5th & Union Mixed Use Hotel

PROJECT #3033058

Recommendation - April 17, 2020

3 RESPONSE TO EARLY DESIGN GUIDANCE

Concept 3 - Harmony (Preferred)

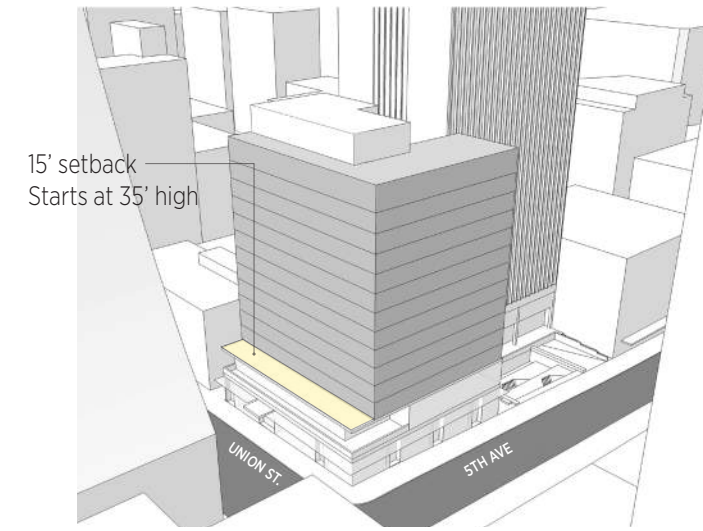
Unanimously approved to
proceed to Recommendation

1. Massing is set back 15' from Union starting at level 3, bringing relief across from the north face of the Rainier skyscraper. By starting the setback lower than is req'd, more light is brought down to the pedestrian level.
2. The low setback defers to the Landmark 'Men's Warehouse' to the West.
3. A two level retail base with a large terrace is formed across from Rainier Square's Level 2 lobby, activating the sidewalk much more than a typical rooftop terrace.
4. The hotel facade is maintained as a simple, more solid form that contrasts the transparency below

Departure 1

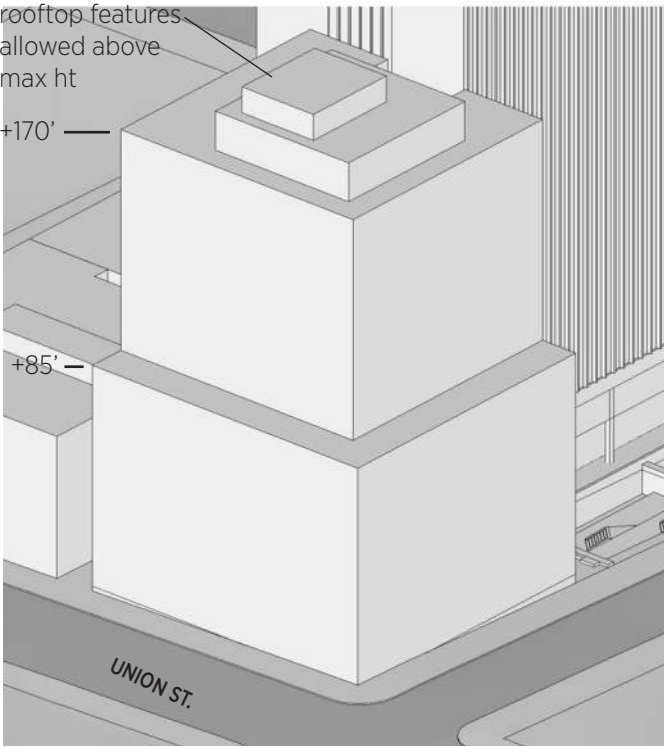
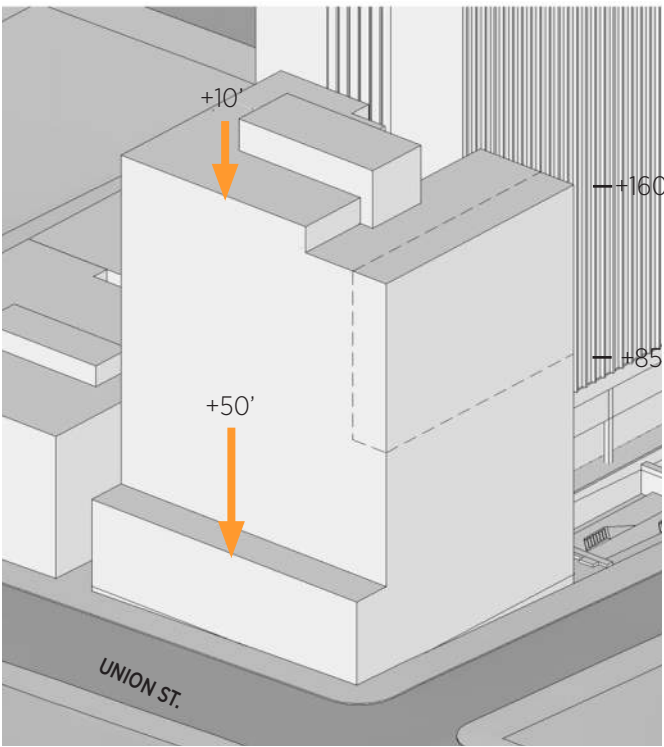
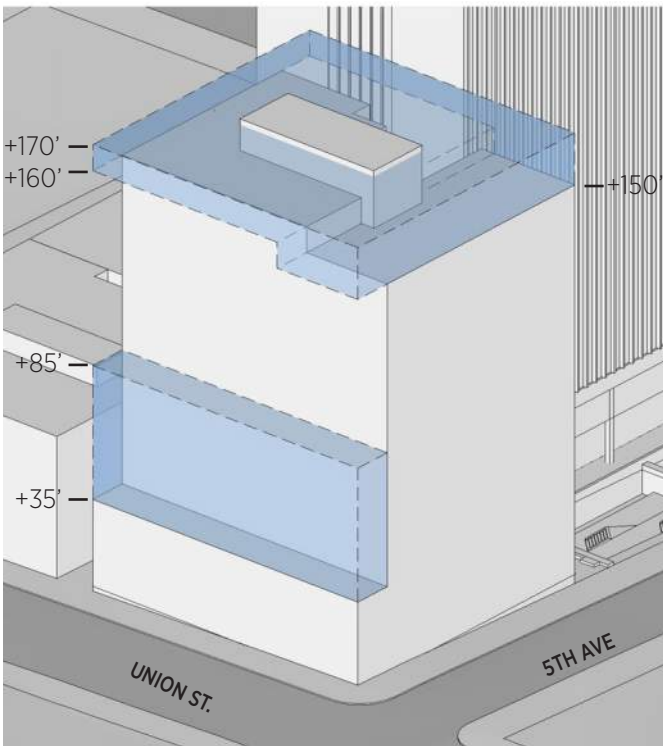
Requirement:
Structure setbacks of 15 feet from the street property line are required for all portions of a building at or above a height of 85 feet above the adjacent sidewalks.

Departure Requested:
The request is to not set back the structure above 85’ high on the 5th Avenue (east) façade.

Mitigating measures:
The proposed design will provide greater volumetric reductions than are required, and it will provide them in locations that will better enhance the Pedestrian experience.

The Departure asks for 96,525 cubic feet of massing to not be set back. However, the proposed design will provide an additional voluntary setting back of massing of 274,049 cubic feet (almost three times the amount of bulk will be reduced elsewhere than is being requested). This is accomplished in two steps:

- The overall building height will be lowered from 170’ maximum to 160’.
- The required 15’ deep structure/façade setback on the Union Street (south) façade will begin 50’ lower on the façade than is required (starting at 35’ high rather than 85’ high).

Departure 2a & 2b

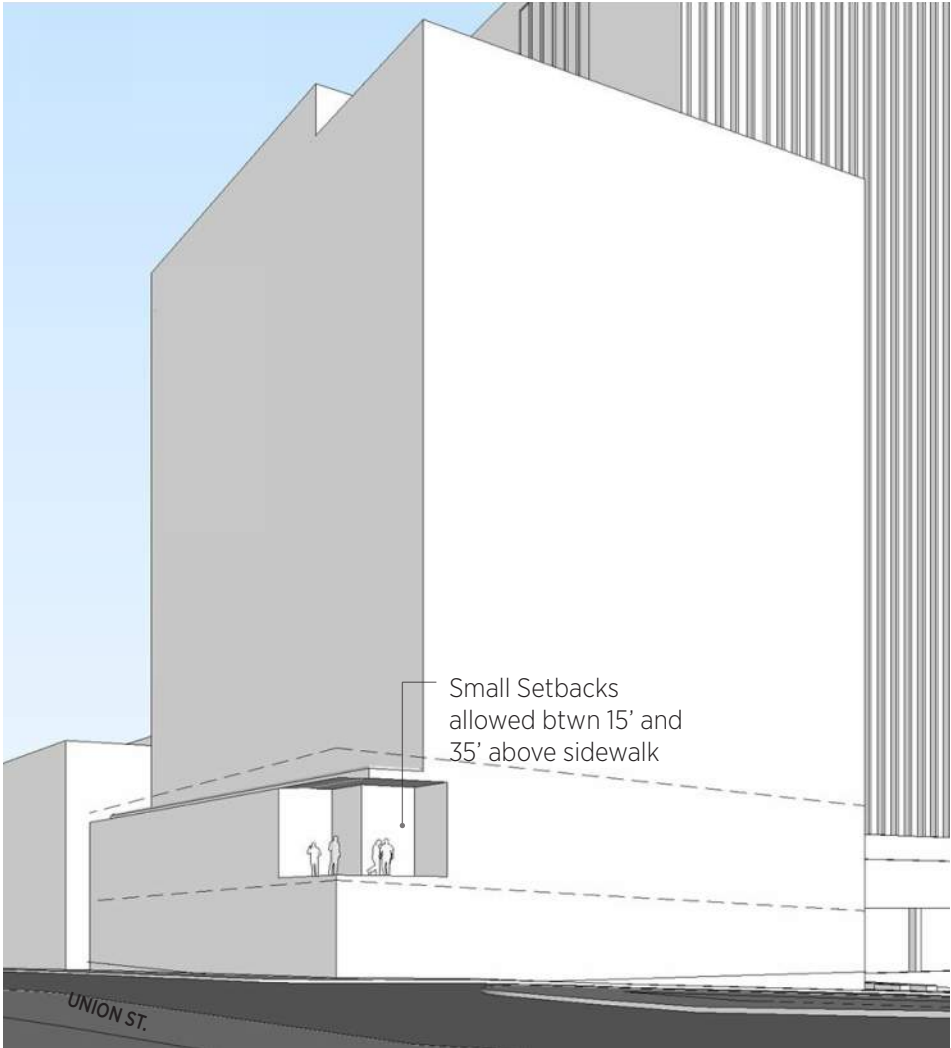
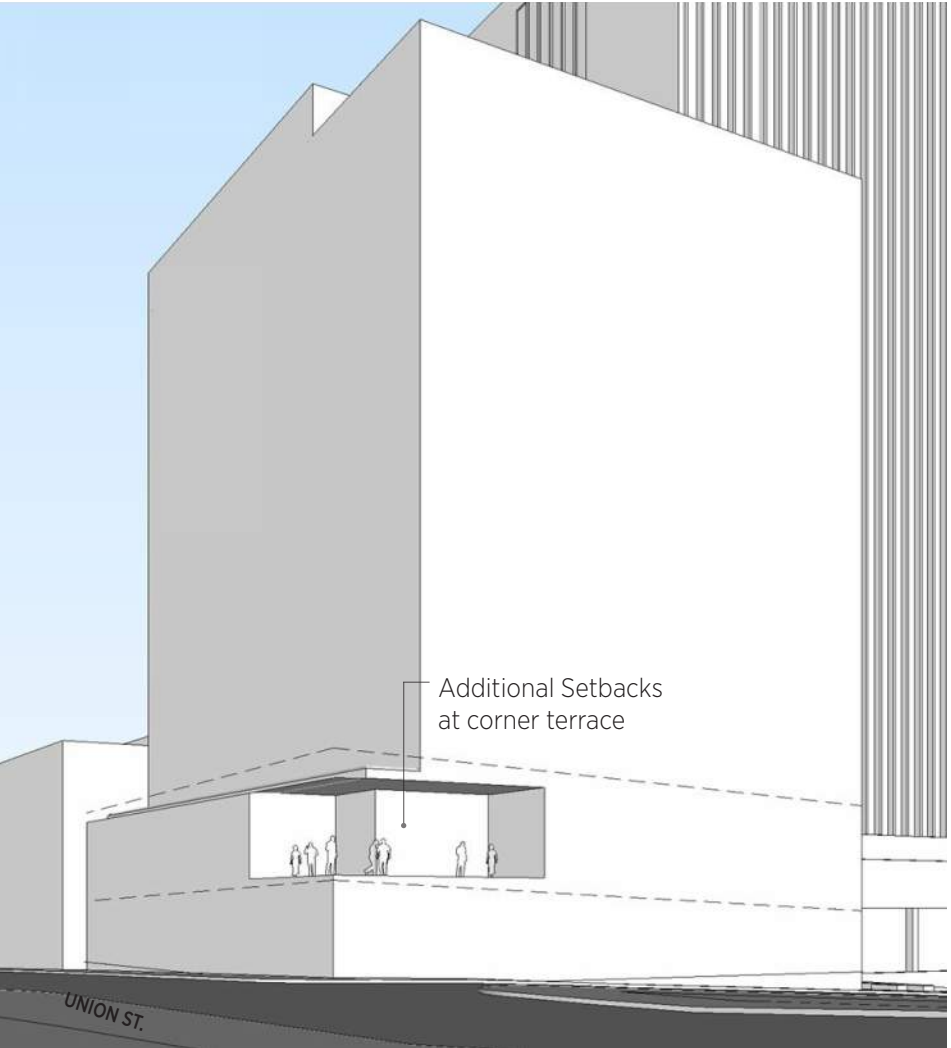
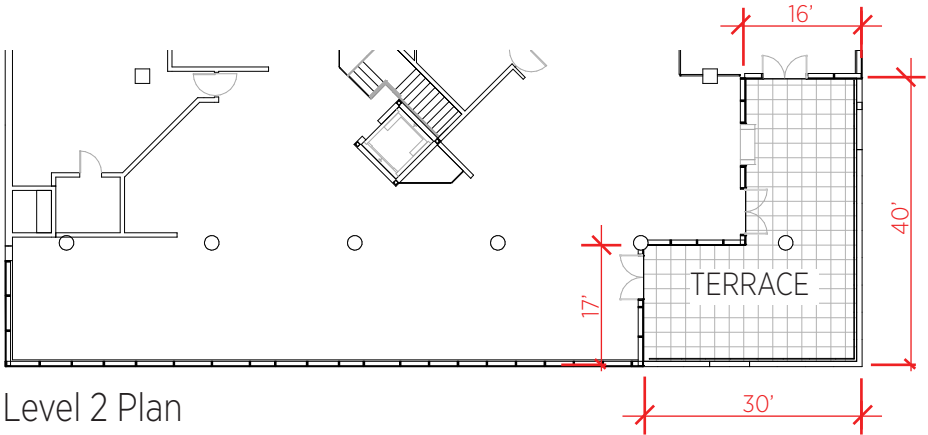
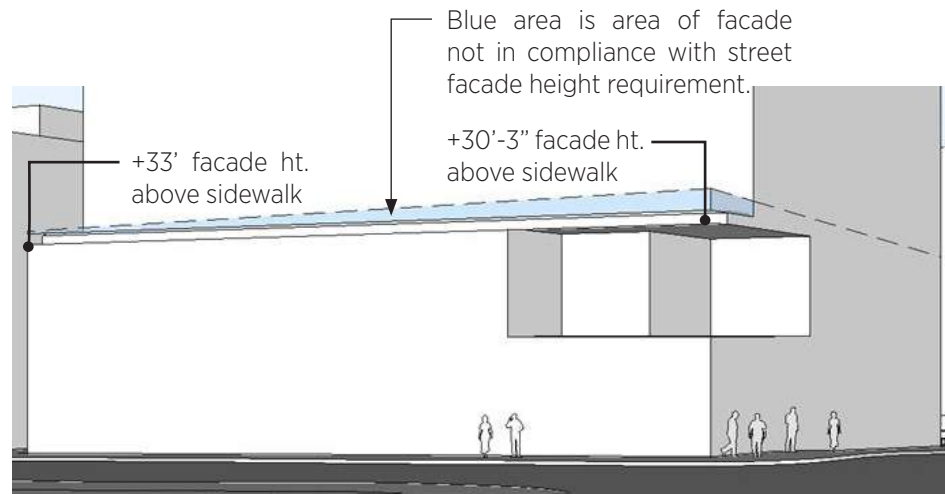
Requirement:
Facade Setback Limits. 23.49.106.B.2.b.

- Between the elevations of fifteen (15) and thirty-five (35) feet above sidewalk grade, the facade shall be located within two (2) feet of the street property line, except that setbacks between the elevations of fifteen (15) and thirty-five (35) feet above sidewalk grade at the property line shall be permitted according to the following standards (see Exhibit 23.49.106 A):

Compliance Table		
D = Does not comply, Departure req'd		
	Union St.	5th Ave.
2a. 1. The maximum setback shall be ten (10) feet.	D (17')	D (16')
2b. 2. No setback deeper than two (2) feet shall be wider than twenty (20) feet, measured parallel to the street property line.	D (30')	D (40')

Departure Requested:
The request is to set back the façade at Level 2 (+15' to +35' high) in greater amounts than is required by this zoning section for the purpose of creating a larger semi-public corner terrace.

Mitigating measures:
The Level two façade setbacks for the corner terrace will not negatively affect the desired Street Façade presence which is desired for continuity on either Union or 5th due to the roof overhang above the terrace which will extend out to within 2' of the property line and form a strong sense of enclosure for the street but also provide greater inside-outside building-street interaction and transparency than would a solid wall.

Rationale:
An overriding goal of the proposed design is to enhance the pedestrian experience, and the terrace at level two is nearly unique in the city in that it will create a public yet semi-enclosed outdoor place to enjoy the city that is visible from, and thus visually accessible by, the sidewalk. Most such terraces are located on rooftops, too far above the sidewalk to affect pedestrian life and vitality. By allowing a terrace to wrap the corner at 5th and Union with generous, usable dimensions, pedestrian's eyes will be drawn up to the most vital part of the city - the street corner.

PROPOSED LEVEL 01 FLOOR PLAN

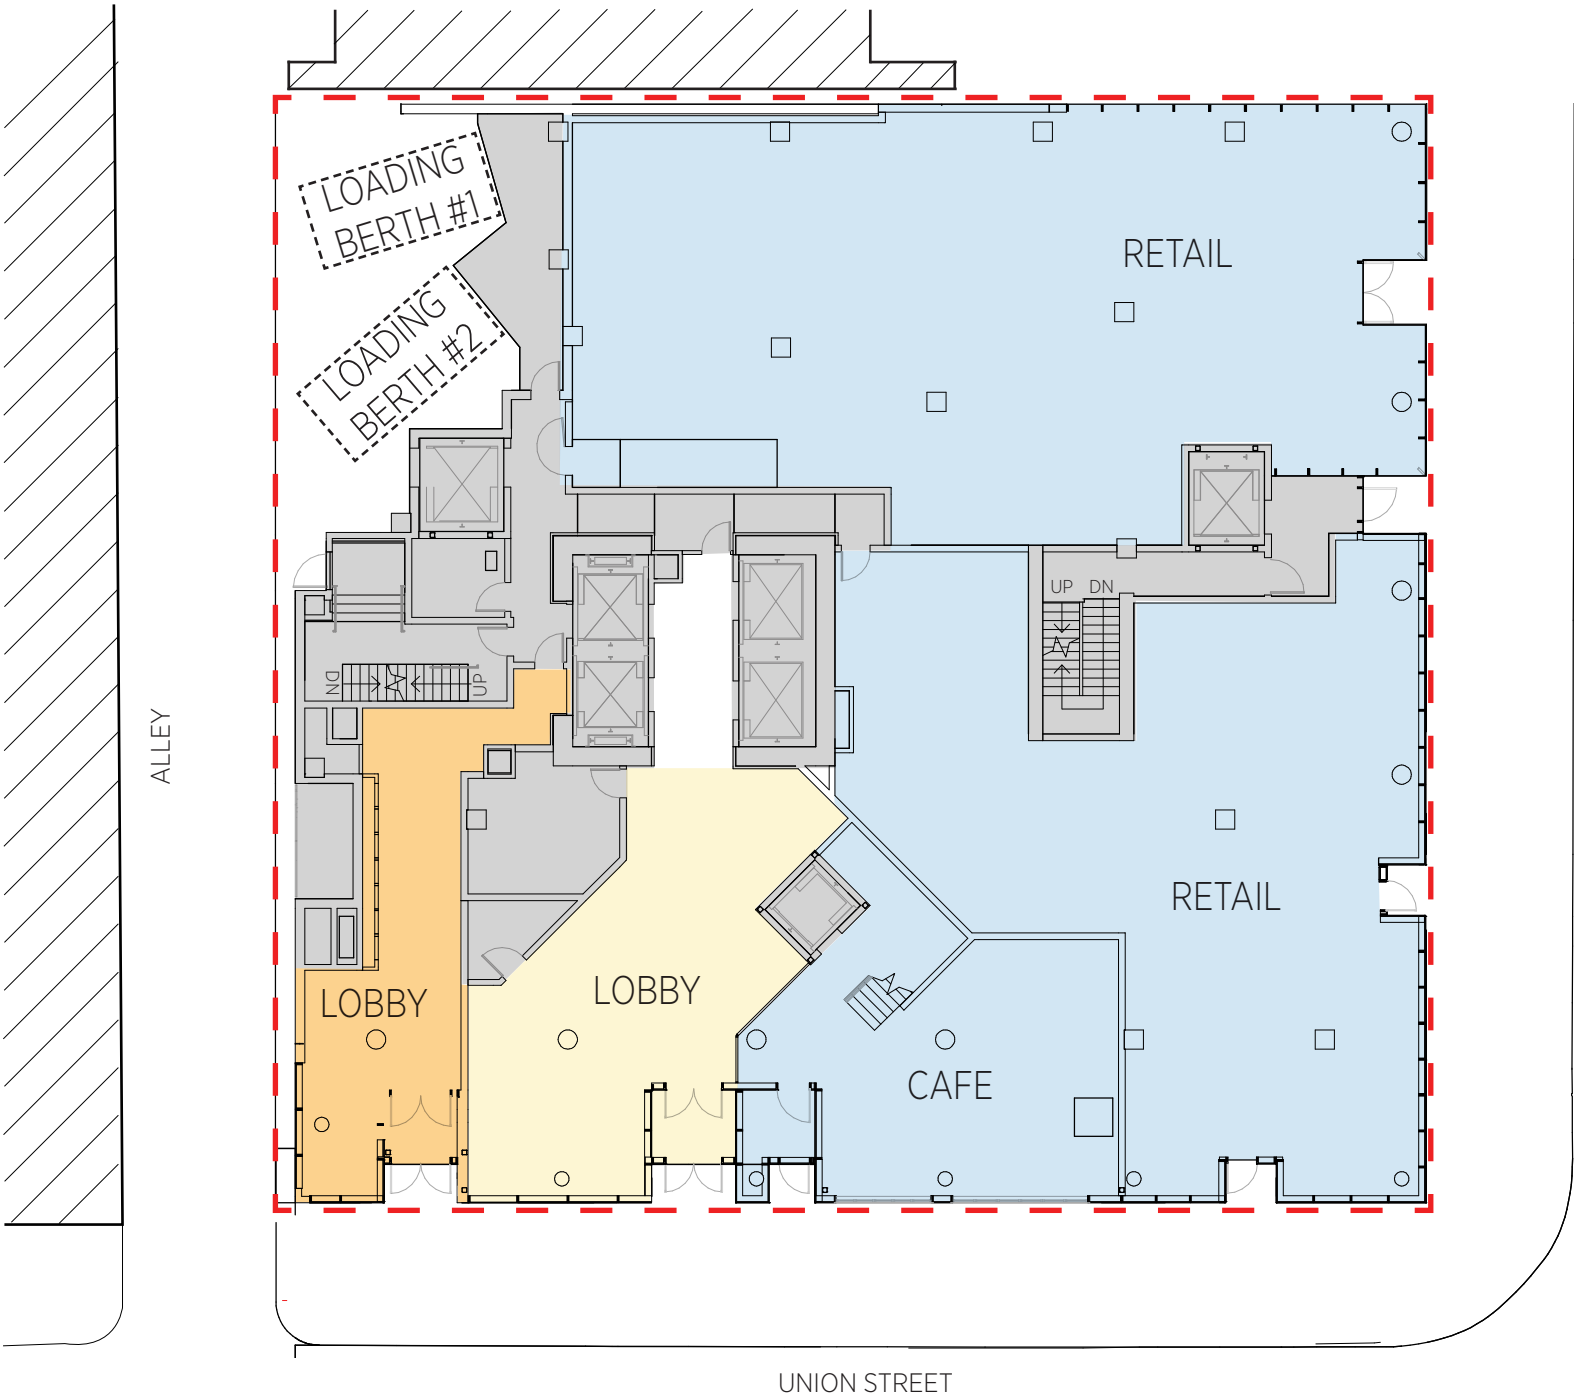
Requirement:
Hotel Use of 85,680 sf: 2 loading berths req'd
Retail/Restaurant Use of 20,700sf: 1 loading berth req'd

3 total loading berths required, each 35' long minimum

Decision Requested:
The request is to allow 2 total loading berths, each accommodating a 23' (DL-23) delivery truck.

Rationale and Mitigating Measures:
The reason for the requested Decision is because the quantity of loading required is too great for the actual need of this proposed, relatively small (in both plan and section) building. Building this additional loading area will take up considerable space on the ground level and substantially reduce the area available for retail tenants, thus being detrimental to pedestrian interaction on these Primary Pedestrian Streets.

SMC 23.54.035.B.2 allows for modification of the loading berth requirements and as such an extensive study has been proposed and is submitted for review with the Seattle Department of Transportation. Please view the following document for detailed rationale and mitigating measures:
